5.2 T140068-2 APP - Development of the land for sixteen (16) dwellings - 13-15 Mahon Avenue, Beaconsfield

APPLICATION NO.:	T140068-2
APPLICANT:	UpCo Urban Planning Collective
LAND:	L1 LP46245, 13-15 Mahon Avenue, Beaconsfield VIC 3807
PROPOSAL:	Amend planning permit application T140068-1 (approved for the development of land for eleven dwellings) to amend what the permit allows by introducing a further five dwellings, totalling 16 dwellings for the site.
PLANNING CONTROLS:	General Residential Zone – Schedule 1
NOTIFICATION & OBJECTIONS:	<p>The proposal was advertised pursuant to Section 52 of the <i>Planning and Environment Act</i> (1987).</p> <p>Notices were sent to neighbouring properties and signage erected on-site for fourteen (14) days.</p> <p>Four (4) objections were received.</p>
KEY PLANNING CONSIDERATIONS:	<ul style="list-style-type: none"> • Stormwater management • Traffic generation and access • Neighbourhood character
REASON FOR MEETING:	<ul style="list-style-type: none"> • Four objections received • Planning Permit T140068 was determined by Council (supporting an officer recommendation for approval)

DRAWING TITLE
STAGE 2 - UNIT 8 - FLOOR PLAN

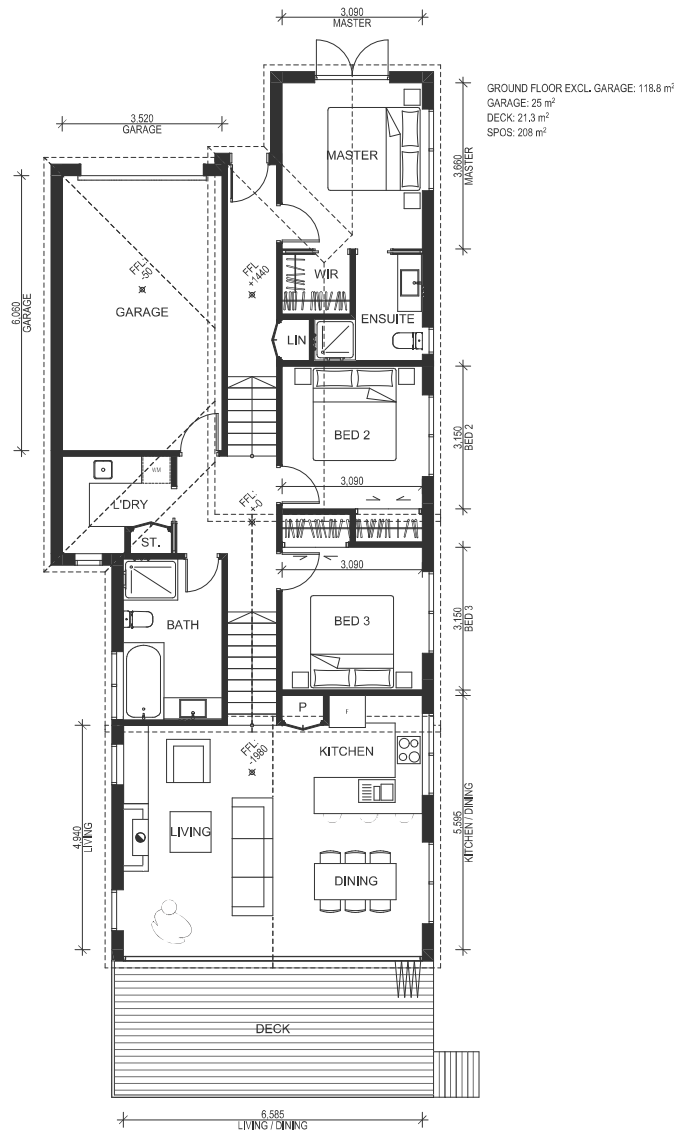
- v. Finished Floor Levels of all dwellings and decking areas.
 - vi. Unit 8 bedroom 3 window to demonstrate compliance with Standard B22 (Overlooking).

DRAWING TITLE:
STAGE 2 - UNIT 11 - ELEVATIONS

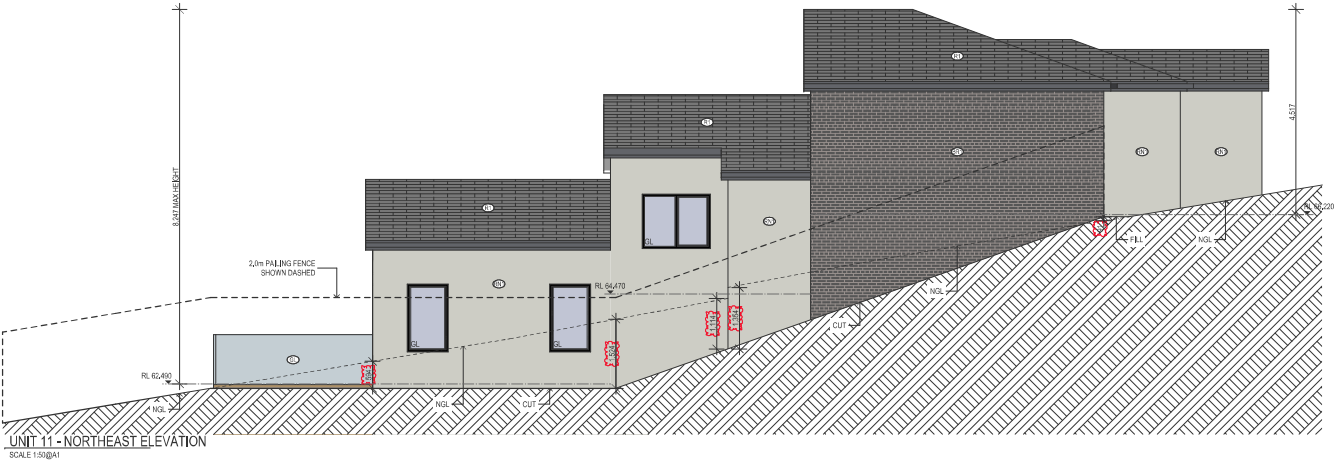
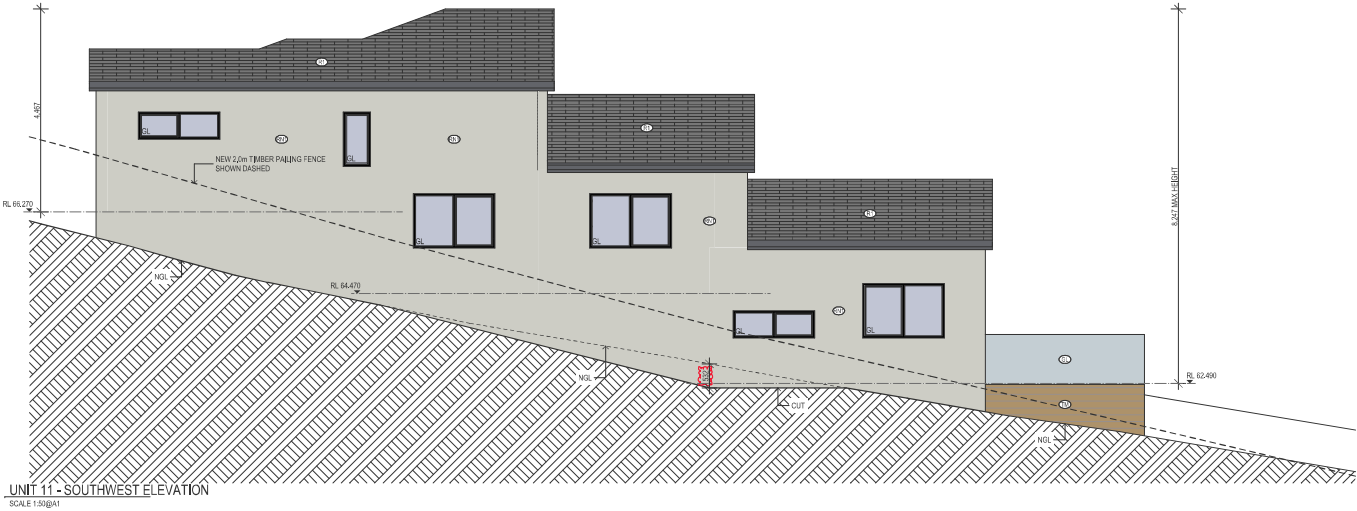
- vii. Unit 11 south-facing windows to demonstrate compliance with Standard B22 (Overlooking).
2. The layout of the site and the size of the proposed buildings and works, as shown on the approved plans, must not be altered or modified without the consent in writing of the Responsible Authority.
